EWS Types

Charlotte Mews Elevation

80 CHARLOTTE STREET

**EWS TYPES** Whitfield Street

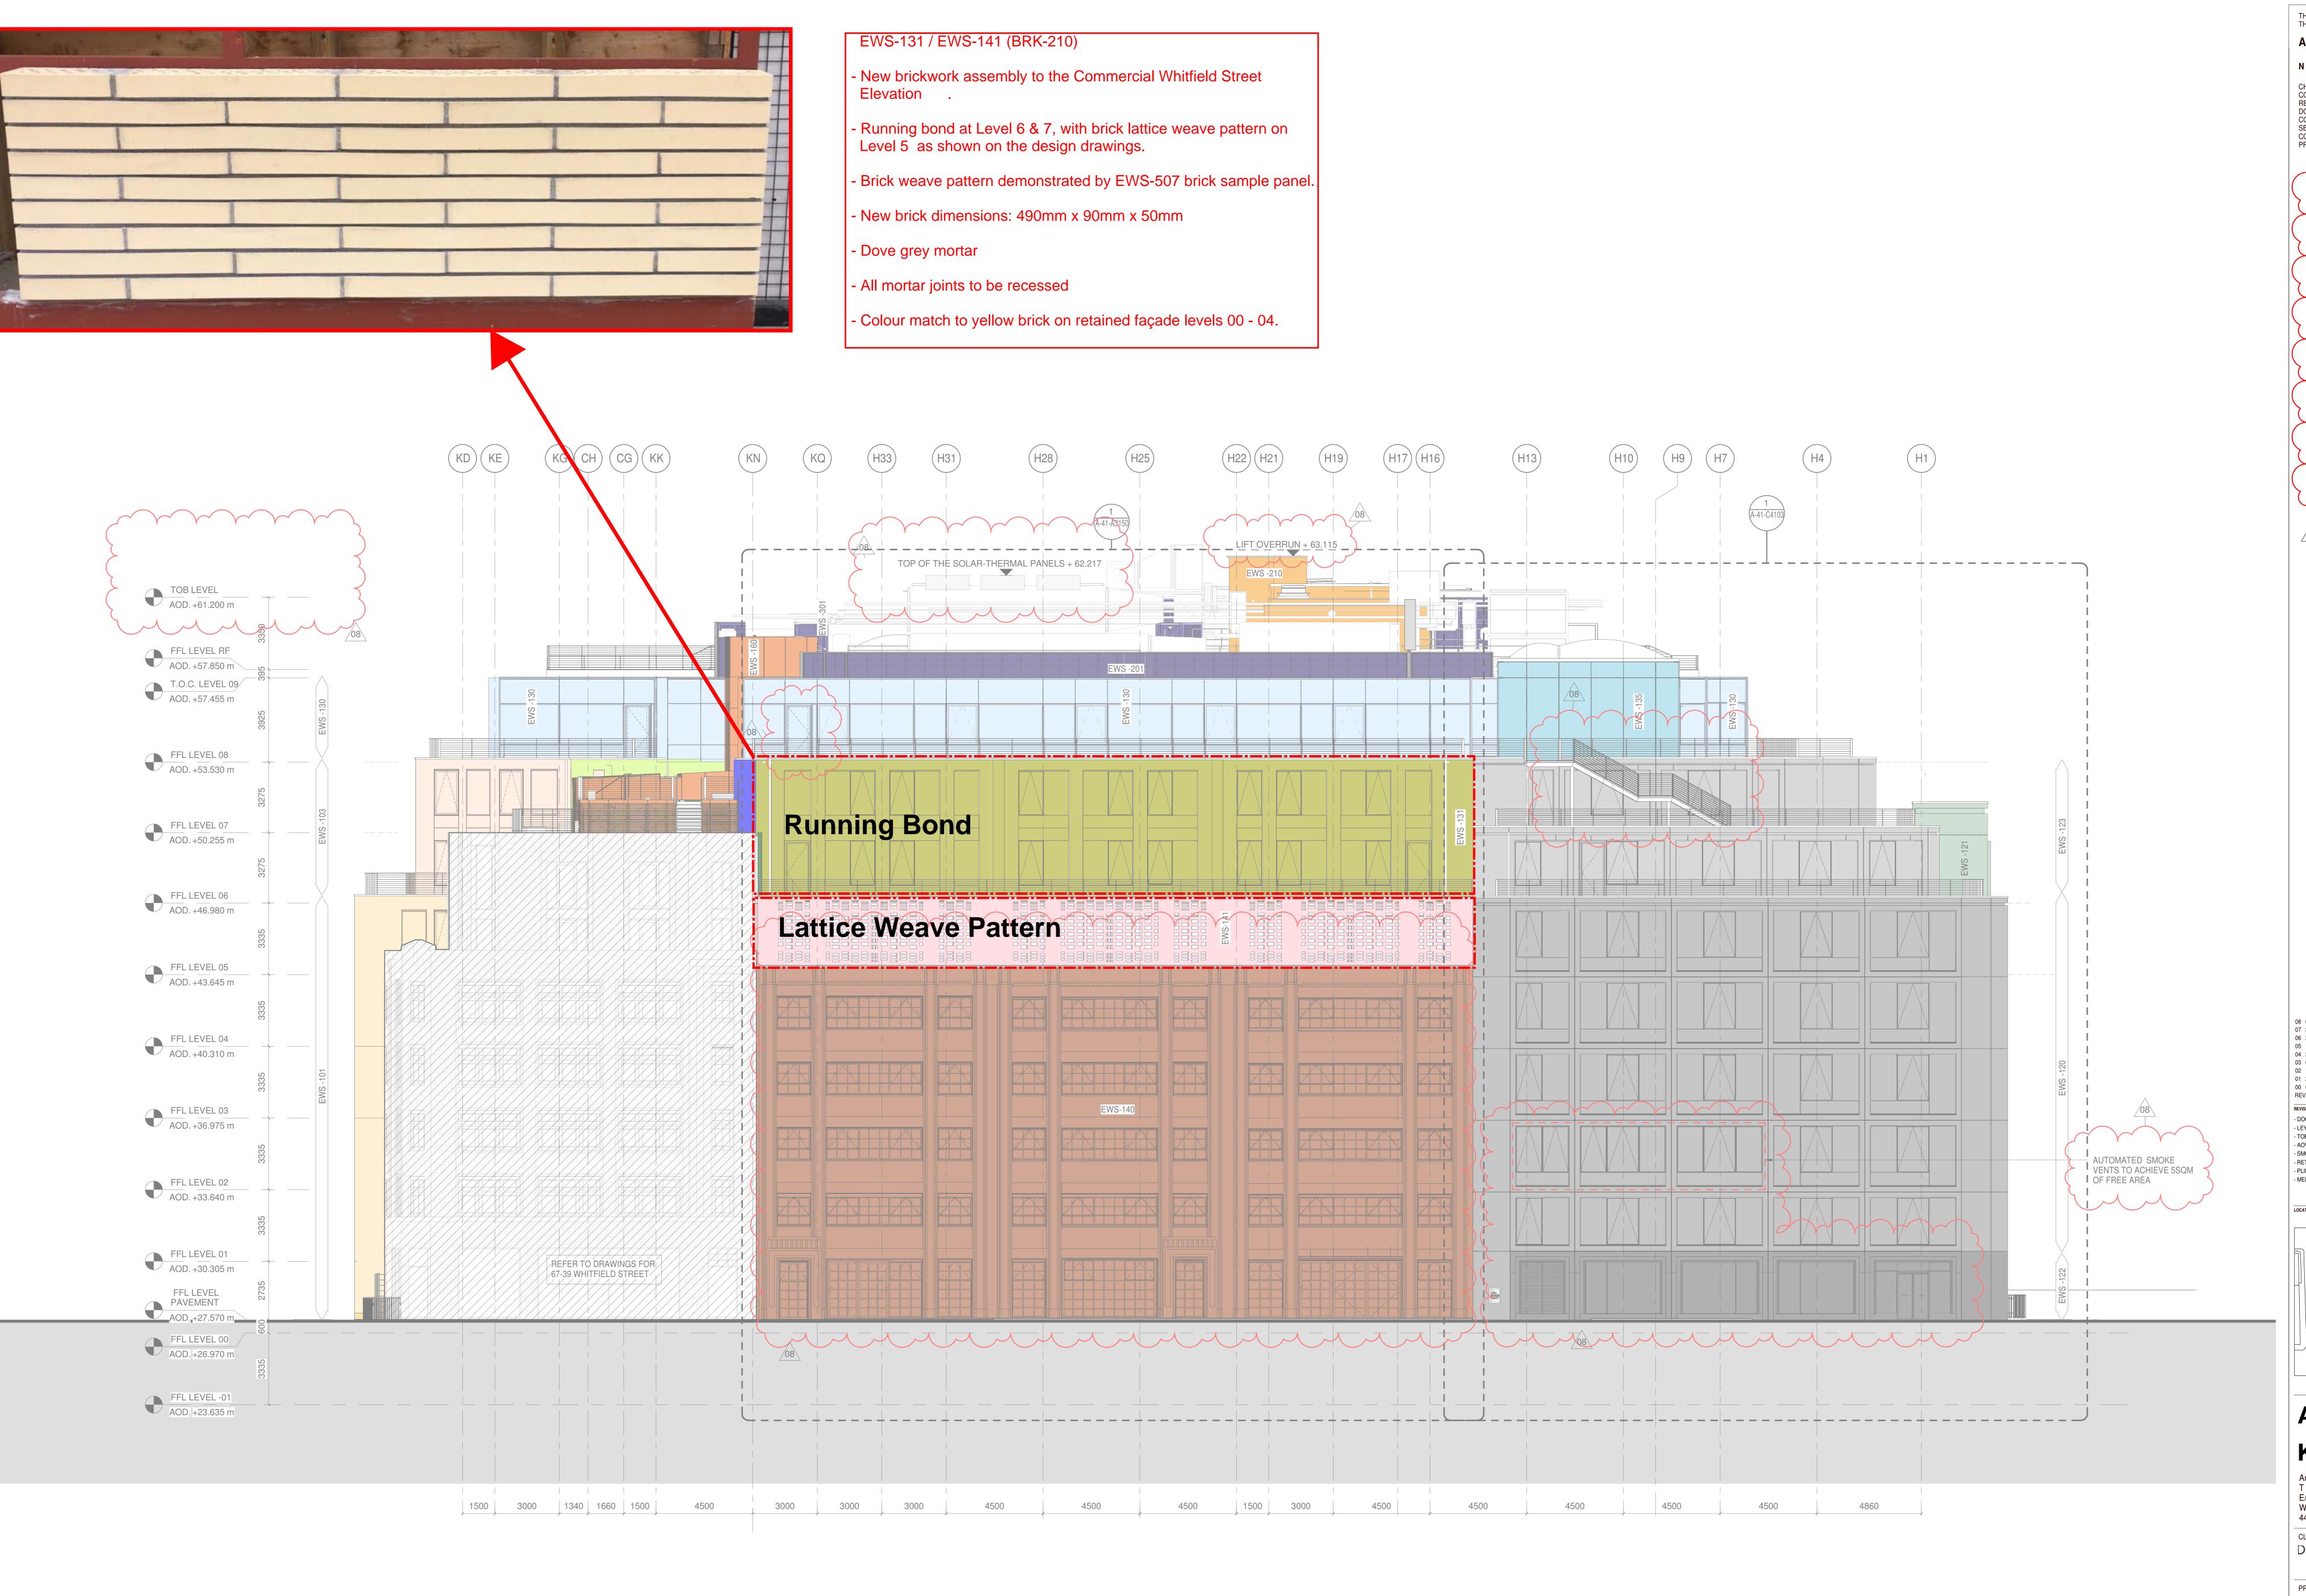
08 01/02/2018 STAGE F PL 07 24/03/2017 UNITIZED FACADE STAGE F ISSUE JML 06 25/01/2017 STAGE E UPDATE
05 12/12/2016 STAGE E UPDATE
04 28/10/2016 STAGE E ISSUE 03 07/10/2016 DRAFT STAGE E ISSUE 01 26/08/2016 CLADDING DRAFT 00 05/08/2016 GA DRAFT ISSUE REV DD/MM/YY DESCRIPTION REVISION 08 COMMENTS - DOORS OPENING UPDATED

- TOB AND OVERRUN LIFT LEVELS AMENDED - AOV SCOPE LINES ADDED - SMOKE CONTROL LOCATION ADDED - RETAINED FACADE SURVEY LEVELS INCORPORATED - PLINTH AT GROUND FLOOR ADDED - MEP TO LEVEL 09 UPDATED TO REFLECT TENANT CHANGES
